Appendix 3.4 - LVIA ANNEXES

EIA Review - Landscape and Trees

(Rev.5)

This Paper summarizes the findings of a Technical Review of the Landscape Impact Assessment (LIA) contained within Chapter 11 of the Environmental Impact Assessment (EIA) Report prepared under Agreement No. CE 17/2019 (CE) Technical Study on Partial Development of Fanling Golf Course Site.

Annex A1: Missing Trees

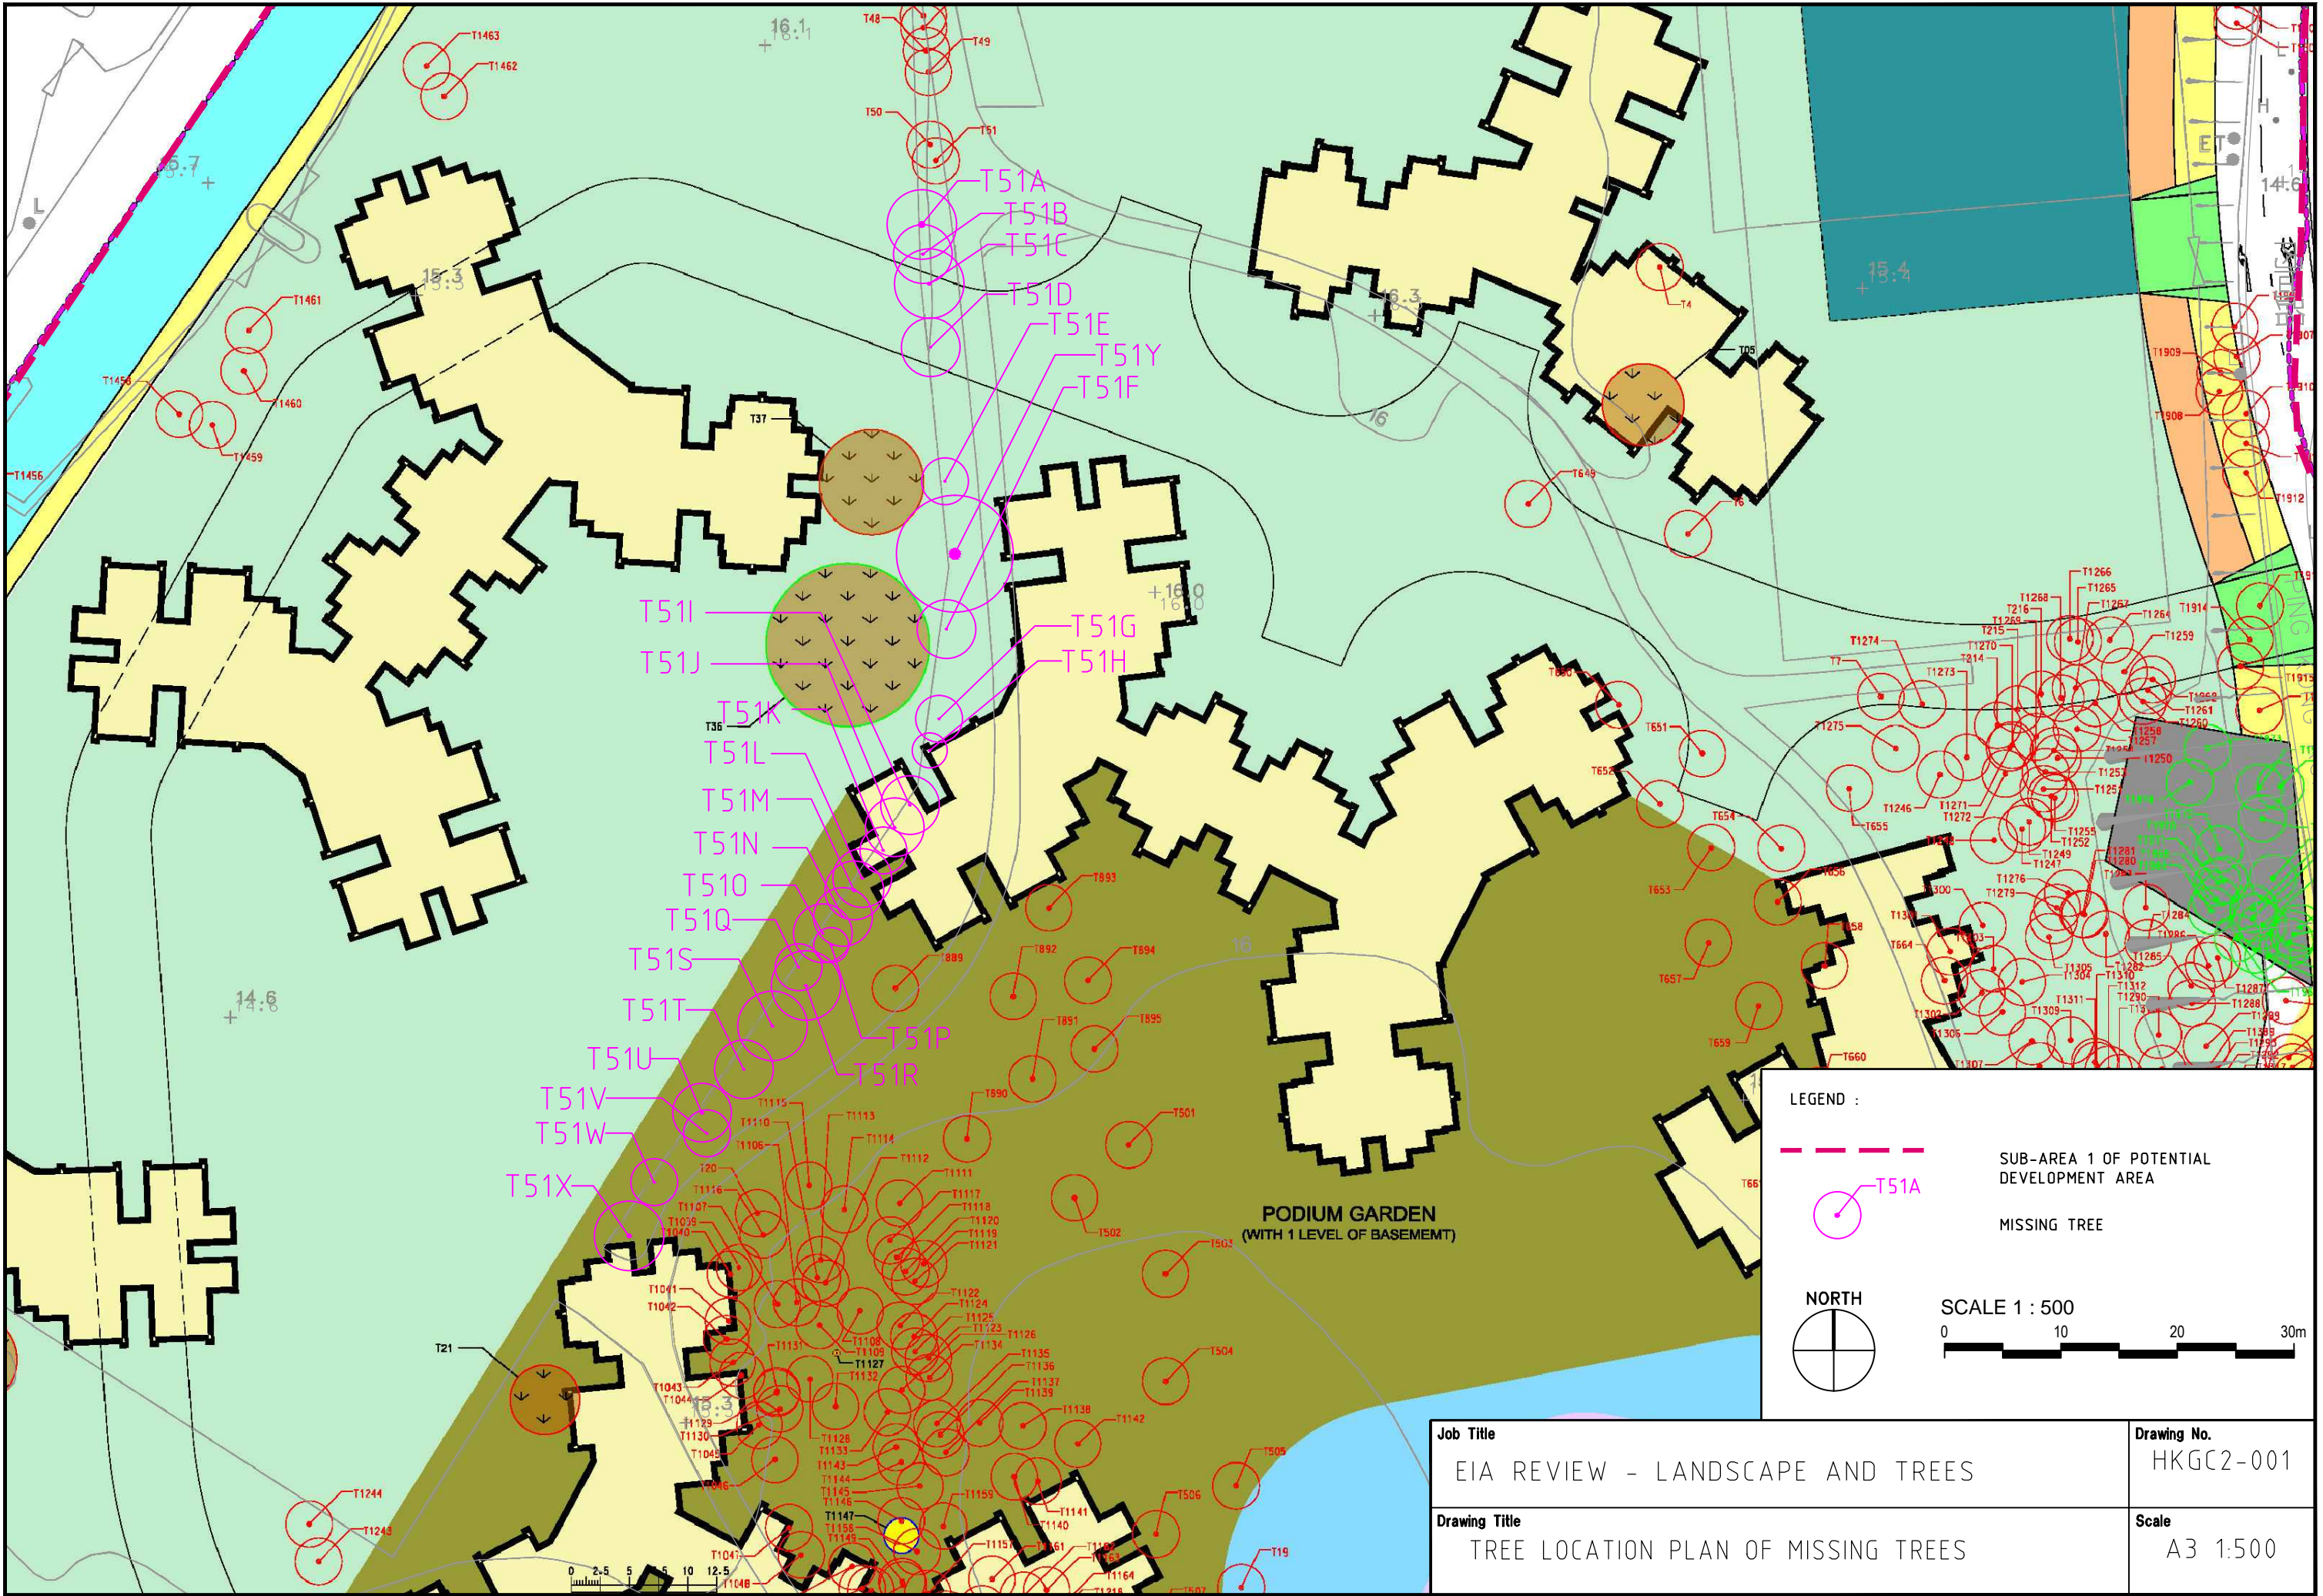
- One very obvious and very large existing tree (*Delonix regia* – girth 917mm) located near trees T36 and T37 is totally missing from the survey plans⁷. This

- Furthermore, 24 other smaller trees in the general vicinity of the Heritage Tree are also entirely missing from the Tree Survey⁹.
- There is inconsistency in the LIA in the reporting of the number of Trees of Particular Interest (TPIs) found in the PDA:
